ECN/PCN No.: M1094

For Manufacturer		
Product Description: 10/100Base-TX RJ45, Tab UP, LED	Abrakon Part Number / Part Series: ARJC01-111002AR	<input type="checkbox"/> Series <input checked="" type="checkbox"/> Part Number
Affected Revision: Initial revision	New Revision: A	Application: <input type="checkbox"/> Safety <input checked="" type="checkbox"/> Non-Safety

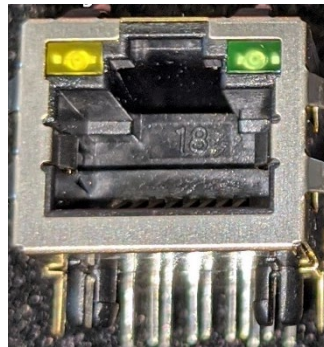
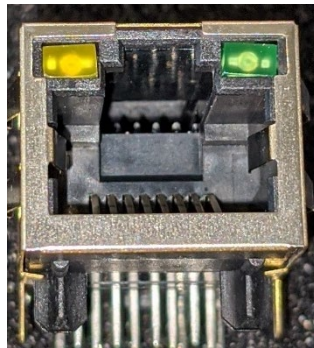
Front (Faceplate) – Front faceplate and LEDs of the original production line.

Part Marking – Marking appears on the back-side of the device and marked using ink.

EMI Fingers – fingertips flare outward from body.

Board Guides – round board guides

Front (Faceplate) – Front faceplate and LEDs of the new production line. LED lenses are slightly more diffused than original production line. This may cause slight variations in luminosity.

Part Marking – Part number will appear on top of device and laser marked (part number shown is for illustration only).

EMI Fingers – fingertips flare inward towards body.

Board Guides – Star board guides

Standard product review. Increased manufacturing lines to support volume.

The changes described here do not negatively impact form, fit or function of the device. Device outline, mechanical dimensions, internal schematic and electrical performance remain identical.
